ANACORTES PLANNING COMMISSION

1. **Roll Call**
2. **Minutes of January 22, 2020**
3. **Correspondence**
4. **New Business**
Pre-Decision Open Public Hearing: Conditional Use Permit - CUP 2019-0002 - to allow expansion of the Grandview Cemetery at 411 Hillcrest Drive.

Project Title	Grandview Cemetery Expansion	Date of Report	March 5, 2020
File Number	CUP-2019-0002 & SEPA Review	Attachment	Site & Landscape Plans
Administrative Recommendation	Approve the site plan subject to the conditions of approval contained in Section B.

Sheet ID: EES2

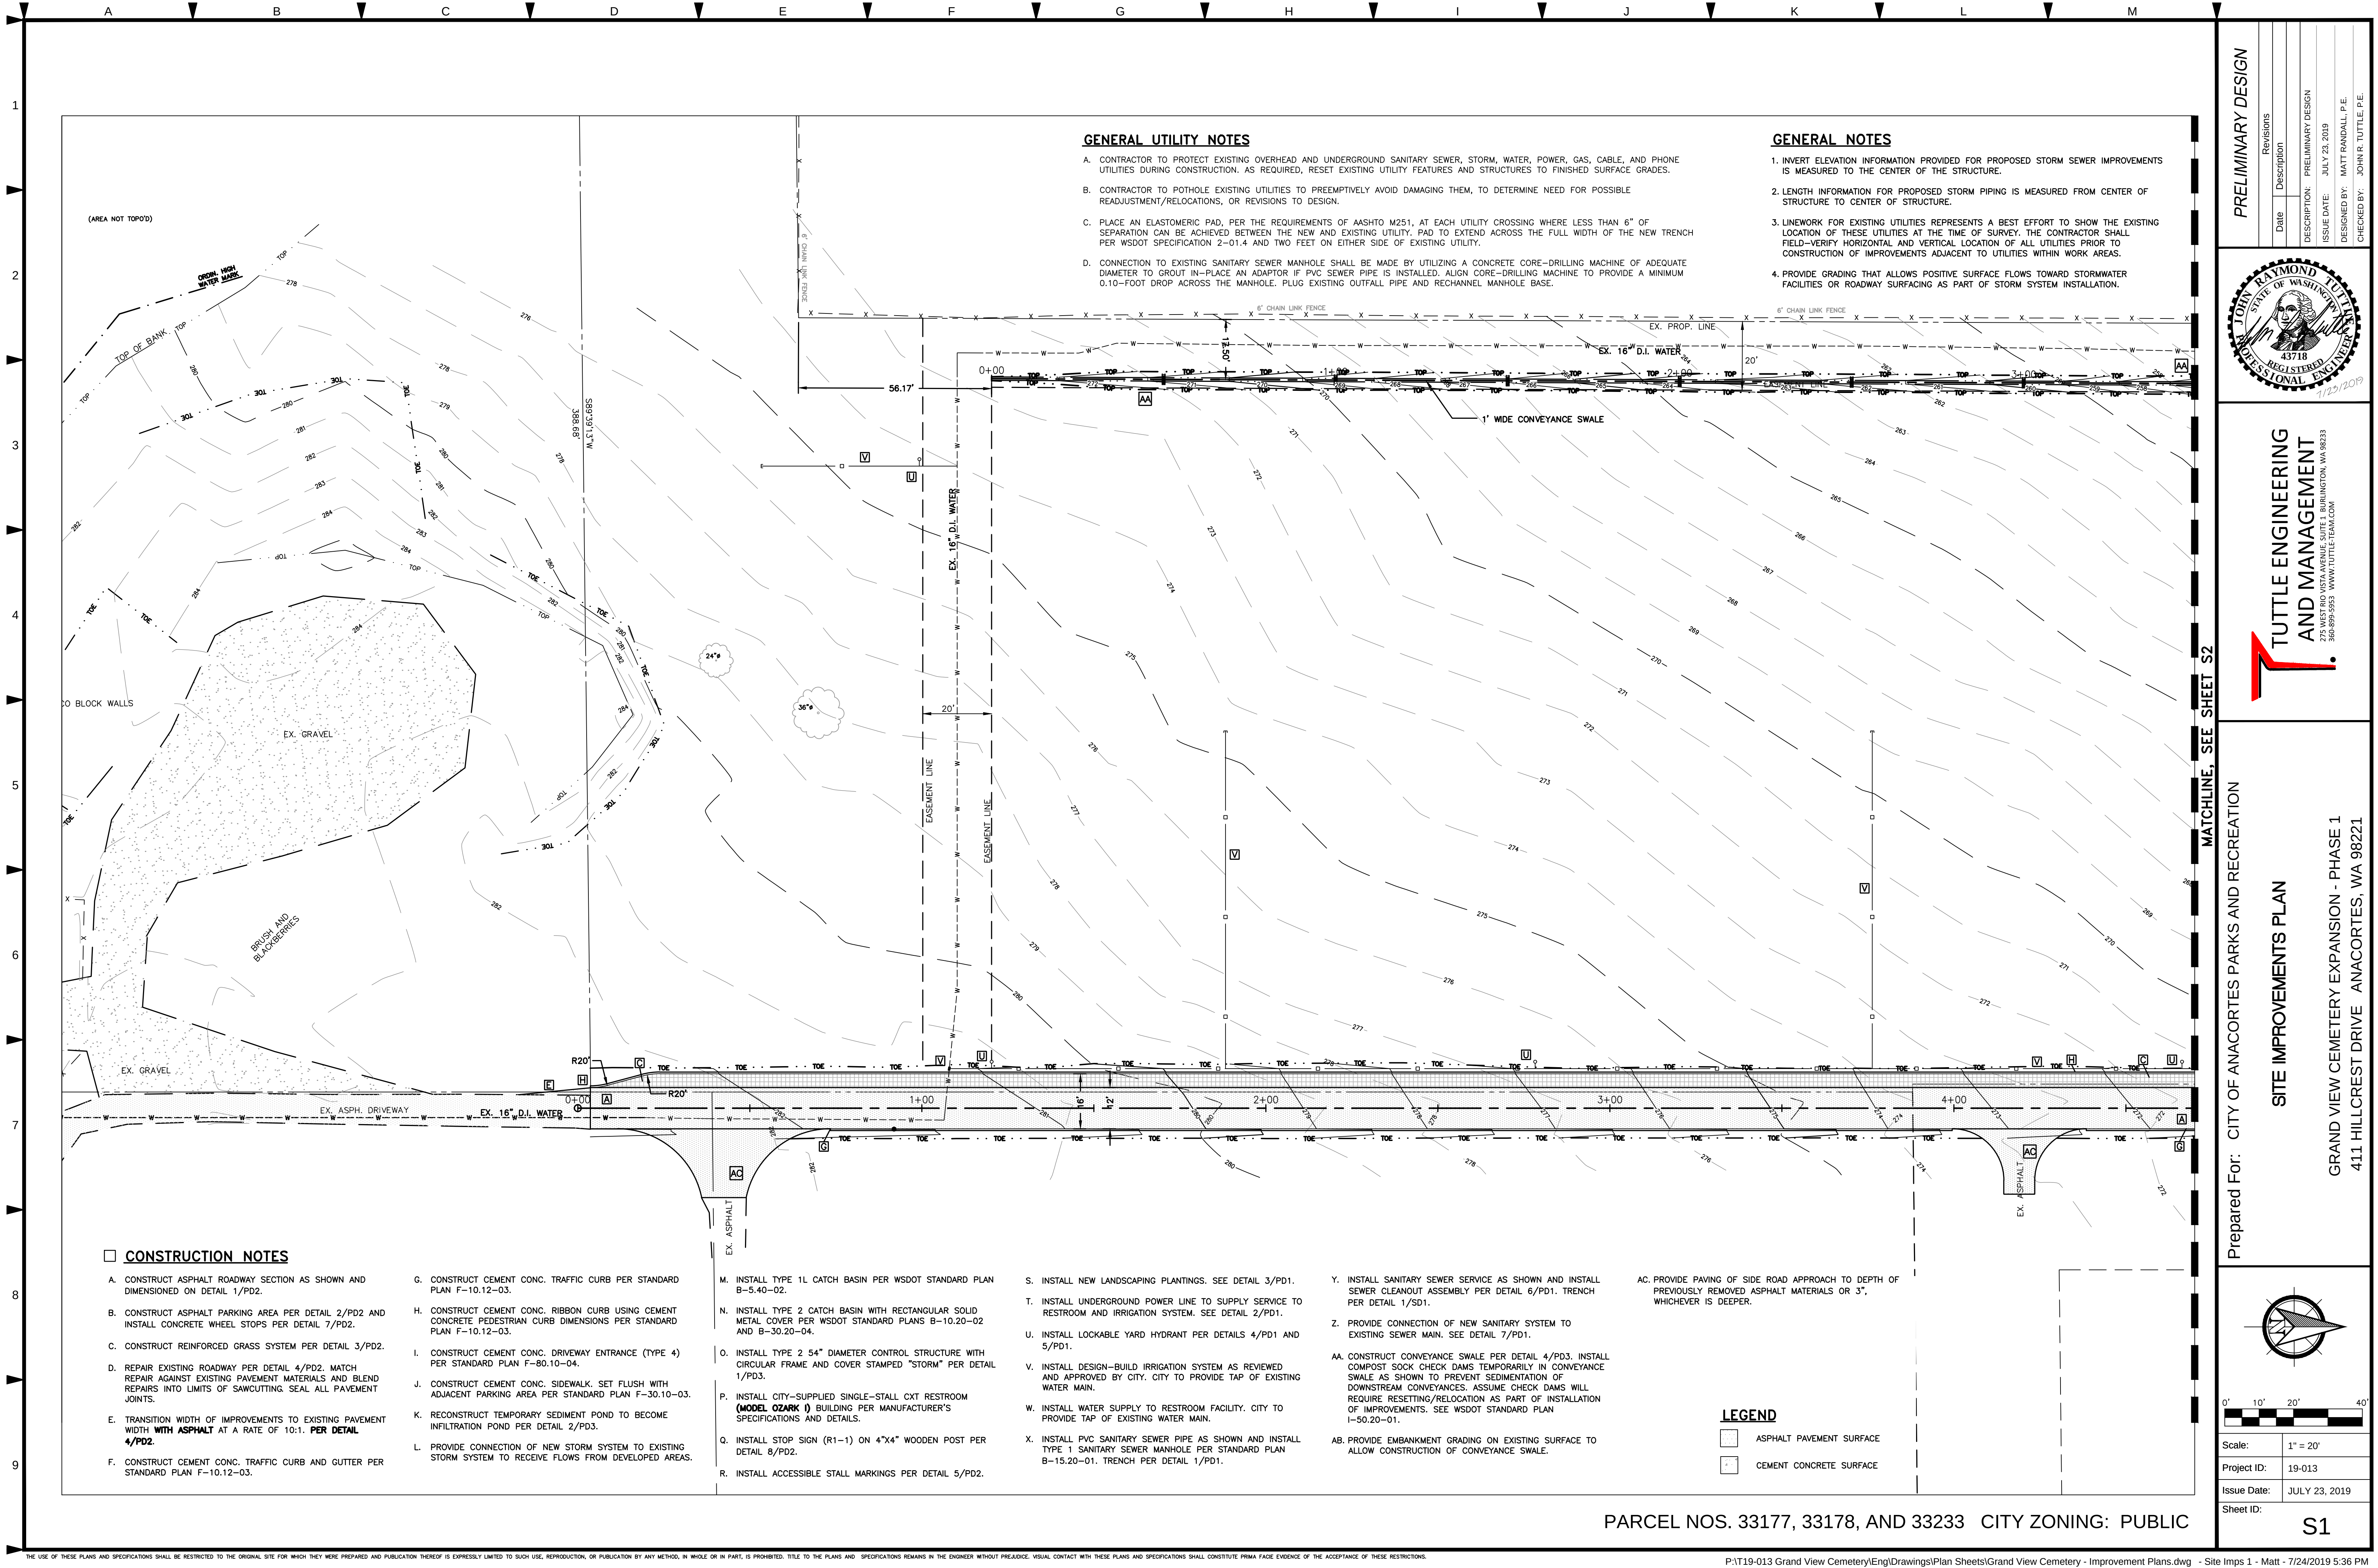
1. Under Minimum Requirement 2 (Construction SWPPP) Element 4, it is noted that a conveyance swale will be installed to direct flows to the sediment pond yet this swale does not seem to be shown on Sheet EES2.
2. Under Minimum Requirement 7 (Flow Control), it appears that the infiltration/detention pond is not sized adequately. From the WWHM output (shown below), the mitigated 2-year flow is greater than 50 percent of the predeveloped flow. Likewise, the 50-year mitigated flow is greater than the 50-year predeveloped flow. Please review the WWHM model and ensure the facility is sized adequately.

GRAND VIEW CEMETERY
INFILTRATION POND CROSS-SECTION
LOOKING NORTH

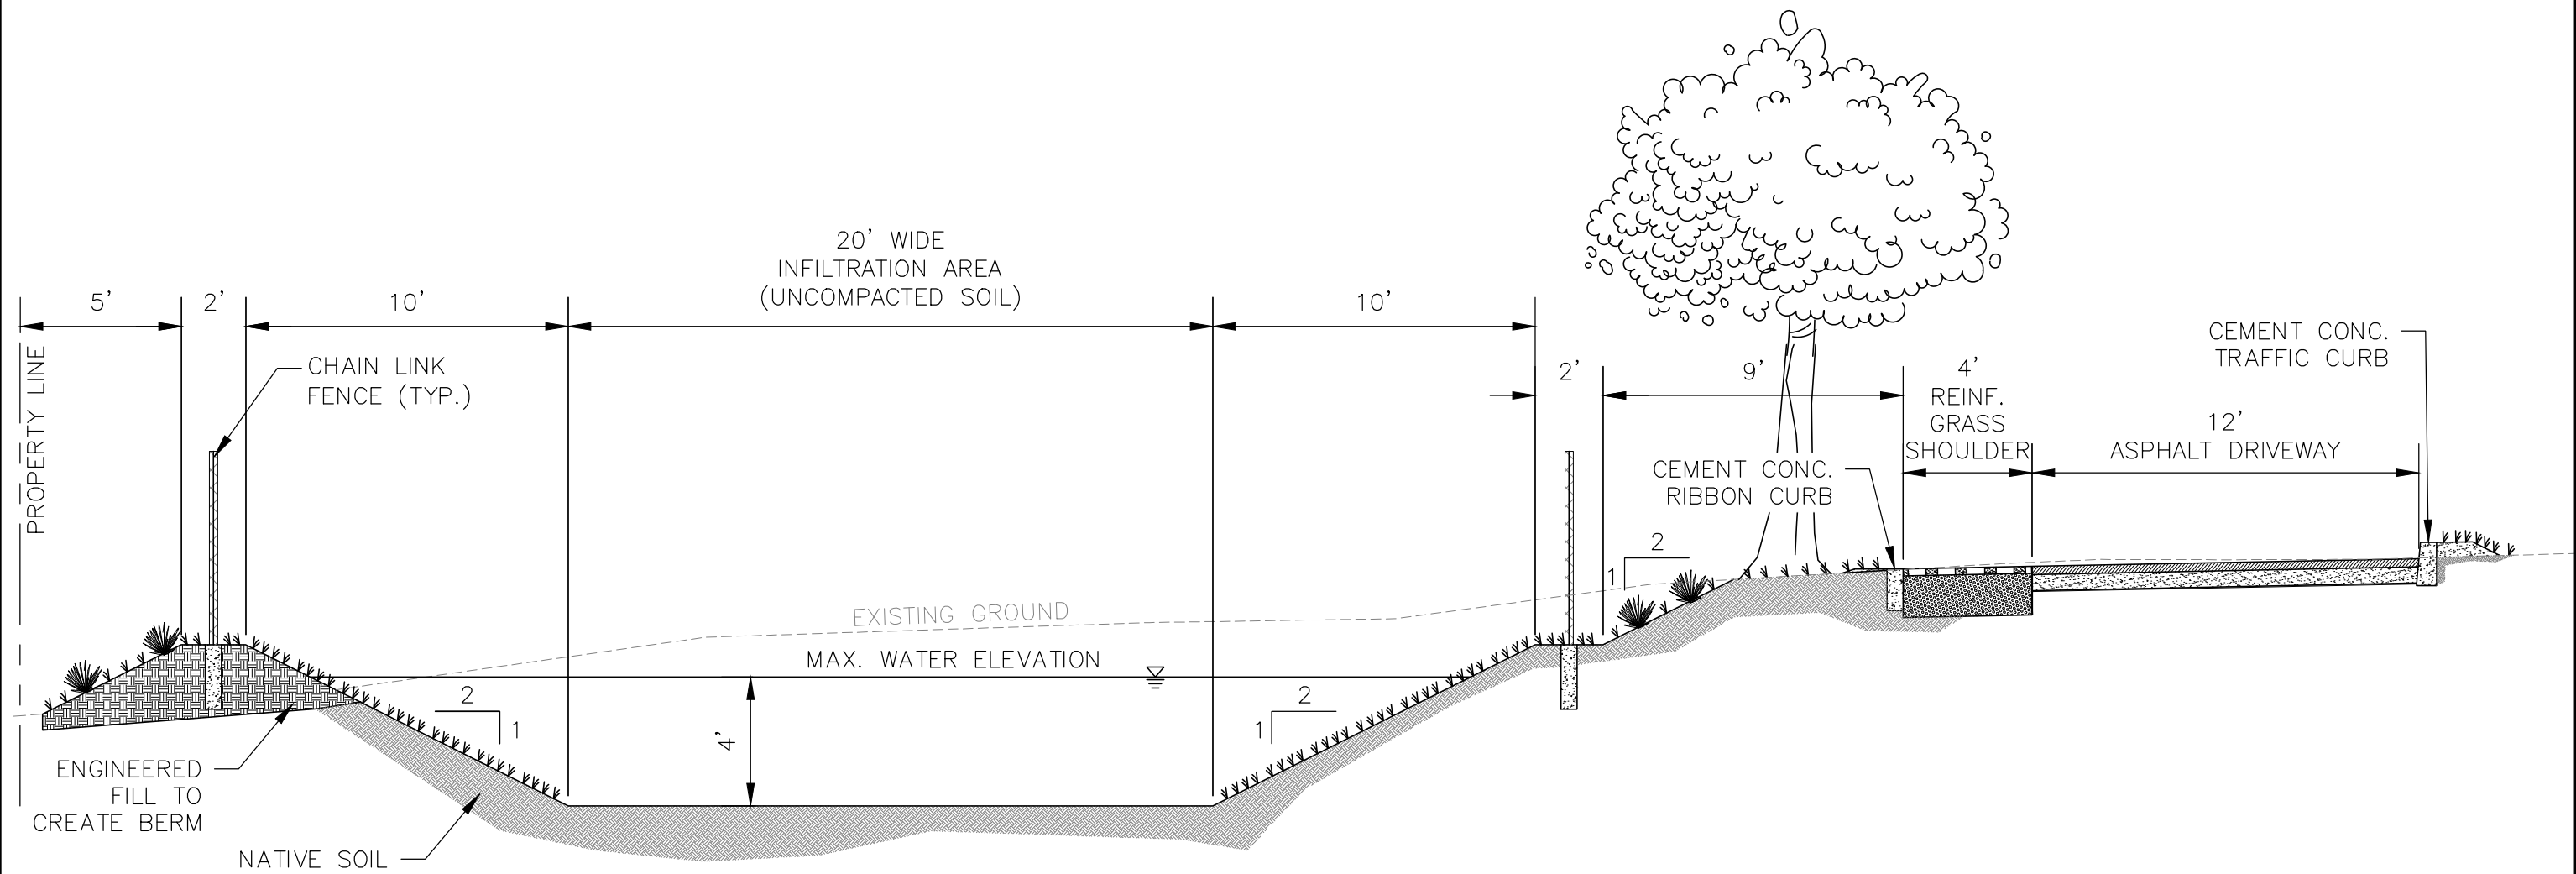
The new city codes require that the detention pond be moved 10 feet from the western property line. (Our drawings show the pond at 5 feet from the west boundary). In addition to moving the pond to the east to accommodate the 10 foot set back, we are adding a few landscape enhancements around it to provide screening for neighbors and aesthetic improvements. We may include a 24" tall land scape wall constructed of Redi Rock, or similar product, to the west of the pond along the property line. If necessary, a wall could provide an adequate border and hold in soils for landscaping materials. A wall would have adequate drain rock placed behind it for drainage.

In addition to our submitted civil plans, we are going to add a few enhancements to the detention pond.
